## RESPONSE TO REQUEST FOR ADDITIONAL INFORMATION

### APR1400 Design Certification

Docket No. 52-046

RAI No.: 356-7881

Figure 7.7-14 I&amp;C System Architecture for the RCC Panel

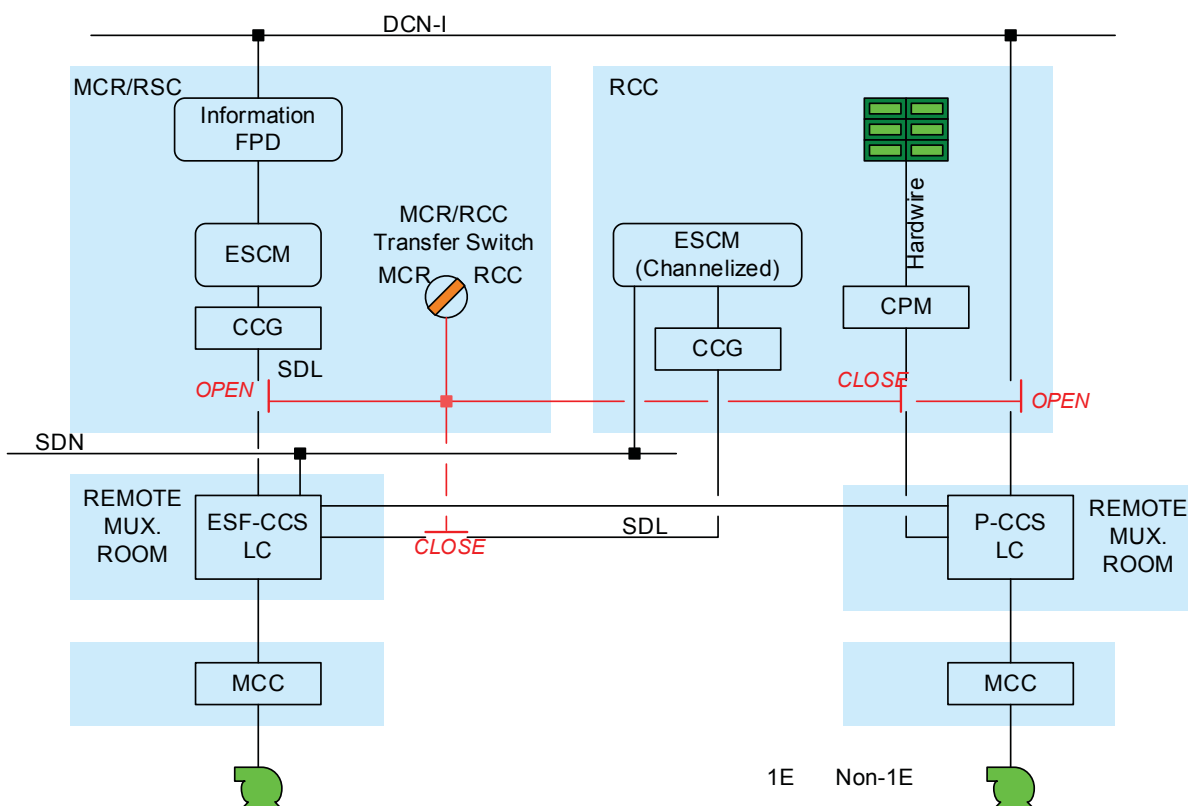
The applicant mentions that the RCC has safety and non-safety related controls available but does not state that RCC complies with any other applicable requirements for this configuration such as independence. The RCC is not depicted on Figure 7.1-1, "APR1400 I&C System Overview Architecture," therefore, there is no physical depiction of how the functionality of the RCC is taken into account within the overall I&C architecture or how its implemented. The acronym for the remote control center is also not defined in the acronym and abbreviation list in Section 7.0 of FSAR Tier 2. It cannot be determined what the difference is between the RCC and RSR.

1. Describe the RCC including all instrumentation, controls, and displays available at the RCC, all communications and architectural details used to implement the RCC, how the RCC addresses all the applicable requirements to the RCC (i.e. Independence), the specific design functions the RCC is intended to meet, the locations of RCC equipment (i.e. I&C cabinets, if applicable).
2. What is the difference between the RCC and the RSR?
3. Have the controls and displays available at the RCC been designed using the human factors engineering process as described in Chapter 18?

DCD Tier 2, Section 7.0 and Section 7.7.1.1 will be revised, and the depiction of the I&C architecture of the RCC will be added as Figure 7.7-14, as indicated in the attachment associated with this response.

The remote control center (RCC) is designed with the following design features:

The I&C system architecture for the RCC panel is shown in Figure 7.7-14
